MEMORANDUM

Date: April 11, 2016
To: Mayor and City Council
From: Brian Malm, P.E., City Engineer
Subject: 2016 Street & Utility Improvements
City of Rushford
Project No.: H19.110554

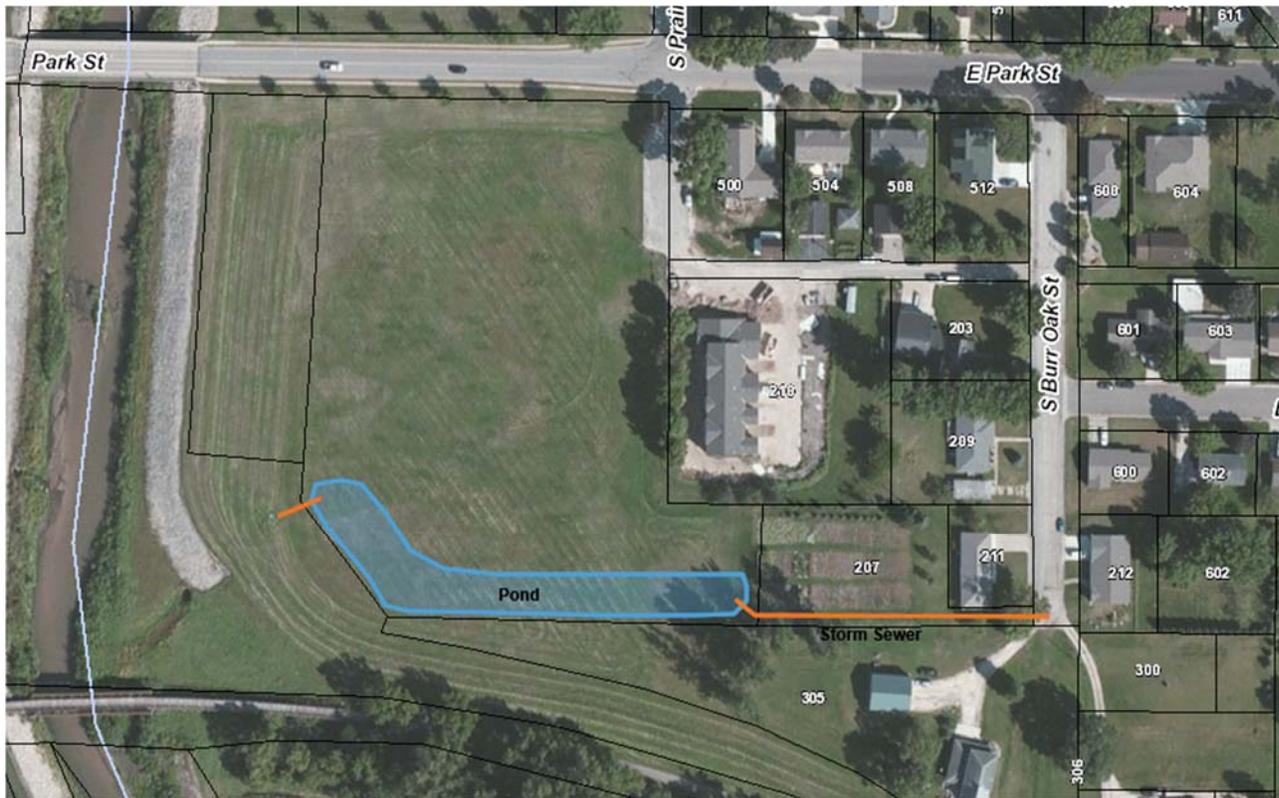
As discussed at the March 14th Council Meeting, and presented at the Neighborhood Meeting last week, there is an alternative solution to the drainage issues at the end of Burr Oak Street. As shown in the figure below, a stormwater pond could be constructed to the west with a larger storm sewer outlet from the end of Burr Oak Street.

The existing levee drainage system outlet at the corner of the levee is low enough to allow for a pond to be constructed and for a 30-inch diameter storm sewer pipe to be extended to Burr Oak Street. The 30-inch storm sewer would accommodate approximately a 10-year storm event (4.5 inches of rain in 24 hours). The pond is needed, not for storage or water quality purposes, but to extend the low elevation closer to Burr Oak Street. While this could be a “dry”, flat swale, we would recommend an open water pond, with a water depth of 3-feet. This will provide some water quality benefit, but mostly help prevent a “dry” swale from becoming a maintenance issue, as they tend to be difficult to mow because they are constantly wet and tend to grow up in weeds. Easements would be required for the storm sewer pipe, but it is understood that the City actually owns the property where the pond is proposed. As with the drain tile system proposed in the Preliminary Engineering Report, Corps of Engineers approval may be required for this option, depending on the connection to the levee drainage system. The estimated cost to change from the proposed drain tile system to the pond and storm sewer is approximately \$115,000.
